Access Compliance Report

Intersection ID: 2984	Main Street: THOMAS_RIDGE_DR	Cross Street: WAVERLY_LYNN_LN	Location: NE
ADA ID: 4F18B1CB4A66	Ramp Type: BlendTrans1	Initial Pass/Fail: Pass	Overall Compliance: No
Severity Score: 15			
Codes/Mitigation Info/Possible Solution		Field Measurements/Component Compliance

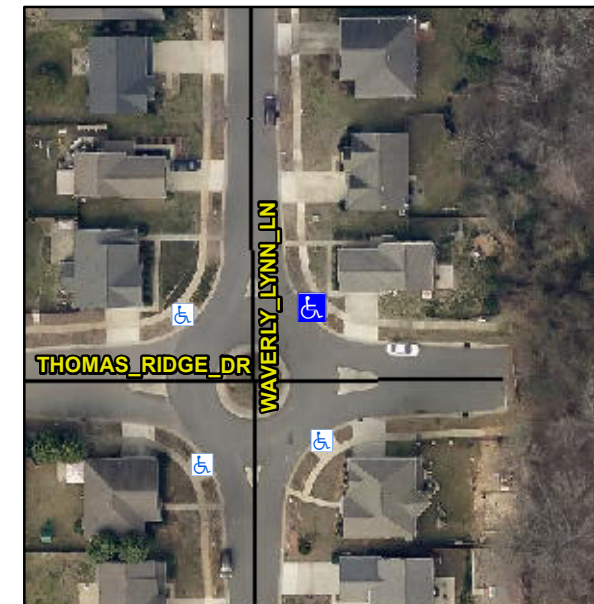
Remove & Replace Detectable Warning System. Remove & Replace Gutter.

R305.1.4, R305.2, R302.7.2, R304.5.4
